UNITED STATES
NUCLEAR REGULATORY COMMISSION
WASHINGTON, D. C. 20555

SUBJECT: MEETING REPORT

Purpose: To discuss the Sandia LOCA test facility performance

Figure 1
 BF3 Conn Qual Test LOCA Temp Profiles

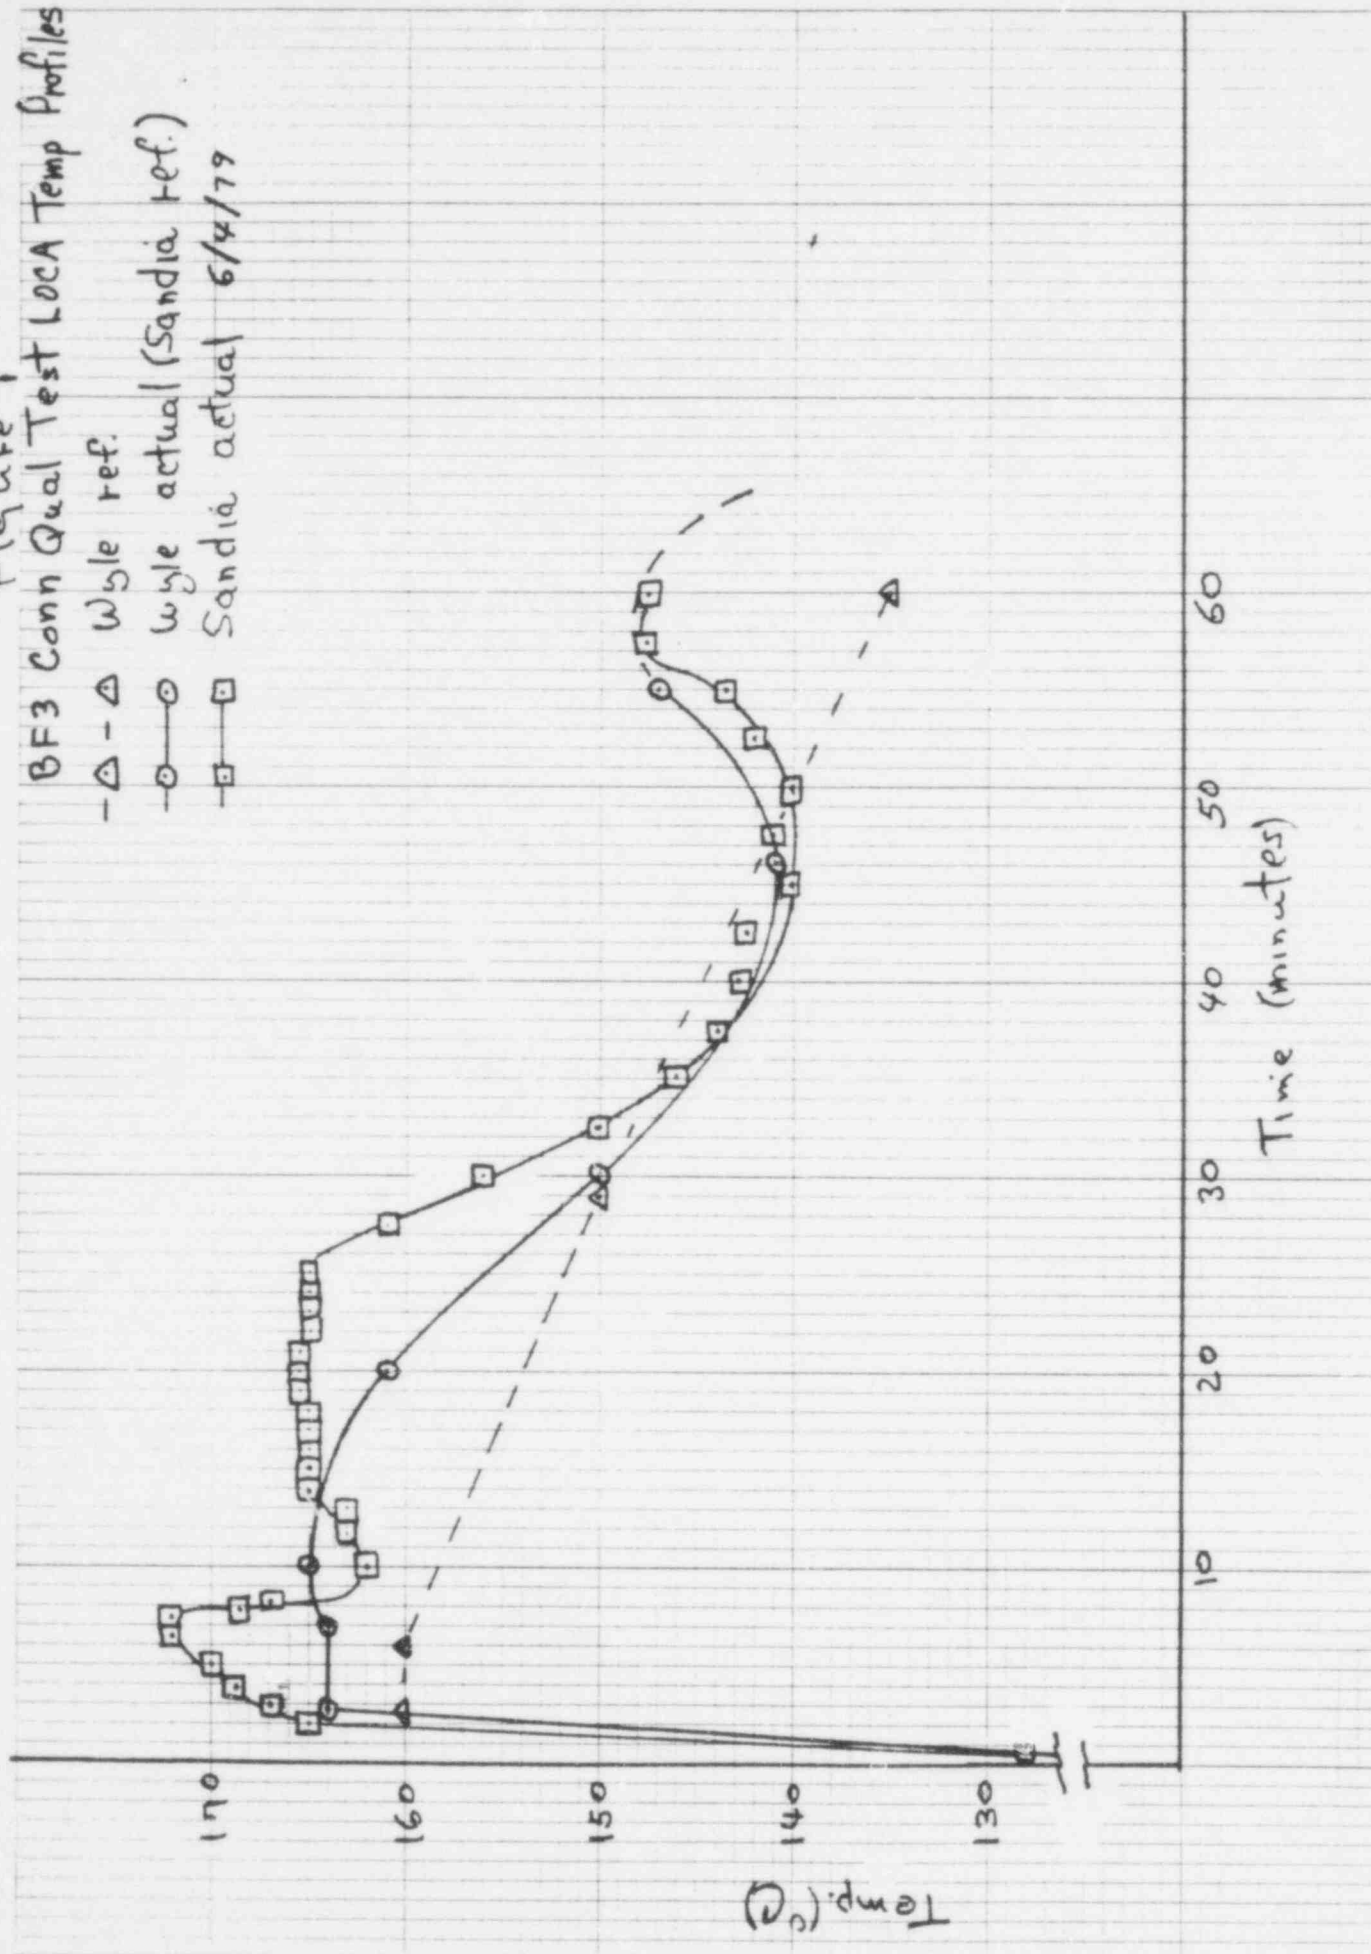
Figure 1 was distributed during the meeting and discussed. It was agreed that Sandia should be allowed to proceed with conclusion of the BF 3 connector test with the following understanding:

1. As previously agreed, the comparison between the Wyle and Sandia test profiles were made using the data taken by Sandia inside the empty connector box. Since the Wyle data only included a test chamber temperature it must be assumed that the temperature profile inside an empty connector box in the Wyle test chamber would follow closely their temperature profile in the chamber.

2. It was agreed by those present that the Sandia profile obtained on June 4 was an adequate representation of the Wyle test profile, and that we should proceed with the steam portion of the BF 3 connector tests. However, it was understood that Sandia would attempt to modify their test procedure to reduce the first overshoot which was about 8°C in the June 4 Sandia profile. Figure 2 shows the temperature profile at a location inside the test chamber (outside of the connector box) in a position comparable to where it was measured in the Wyle test. Although this Sandia profile does follow the Wyle (actual) profile more closely, it is probably not as true a representation of what environment the connectors will be exposed to as the profile in the connector box. Subsequent to the review group meeting, Sandia conducted an additional test on June 7, 1979, in which they were able to more closely reproduce the Wyle test data. This data is shown in Figure 3. Please note that the Wyle reference temperature profile shown in Figure 3 is correct and that there is a 25°C error in the early portion of the Wyle reference profiles in Figures 1 and 2. An error band of +8°C and -4°C was considered reasonable for the connector test. It was also agreed that the Wyle (actual) pressure profile should be followed. The tolerance suggested by Sandia for the pressure profile is ± 5 psi.

3. Sandia will conduct a trial test without connectors prior to the actual test to demonstrate that the actual profile will be at least as close to the Wyle profile as the attached profile (Figure 1). The test will be conducted using a written and approved procedure that is intended to be identical to the one used for the actual test. The test procedures will include all pretest checks as well as the sequencing of valves, reference times and temperatures.
